Federal Register

Monday, July 16, 2007

Airworthiness Directives; Bell Helicopter Textron Canada Model 430 Helicopters

ACTION: Notice of proposed rulemaking (NPRM).

Figure 1

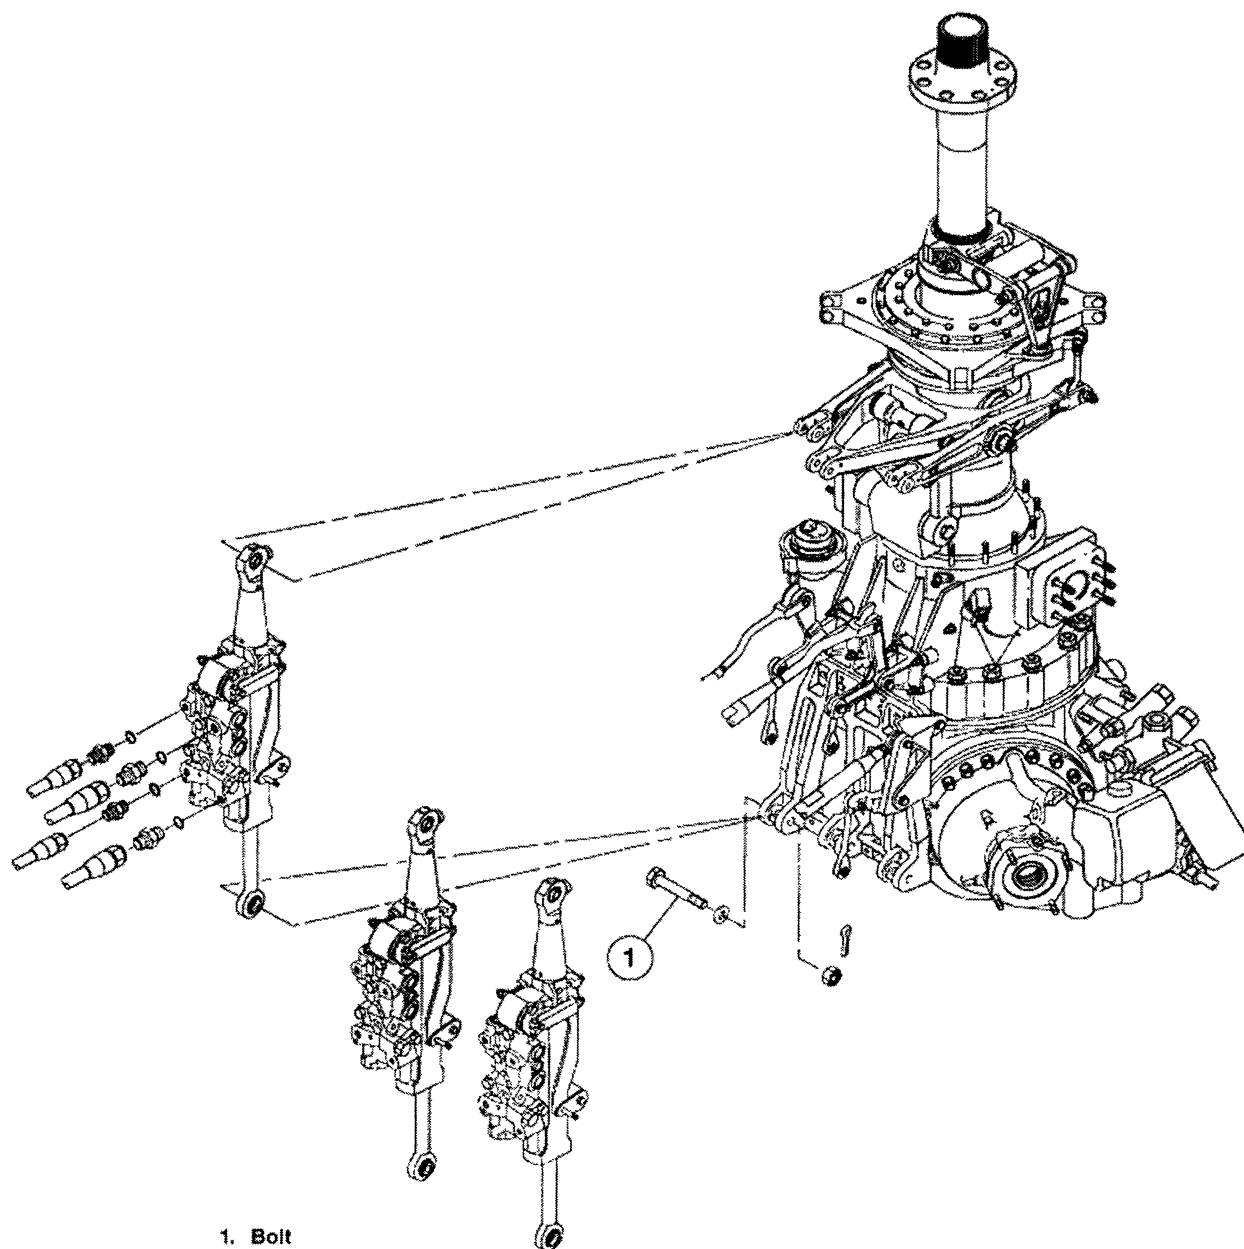
- (a) Within 150 hours time-in-service (TIS), replace all three affected bolts, as depicted for one of these bolts in Figure 1 of this AD, with airworthy, zero-time bolts, P/N 50-047C8-31.

Note: Only the right servo lower attach bolt (1) is shown. The collective and left cyclic servo lower attach bolts are also to be replaced. (This AD does not apply to the same part-numbered bolts at the upper end of each servo.)

(b) This AD revises the Airworthiness Limitations section of the maintenance manual by establishing a retirement life of 5000 hours TIS for each bolt.

(c) Record a 5000-hour TIS life limit for each bolt on the component history card or equivalent record.
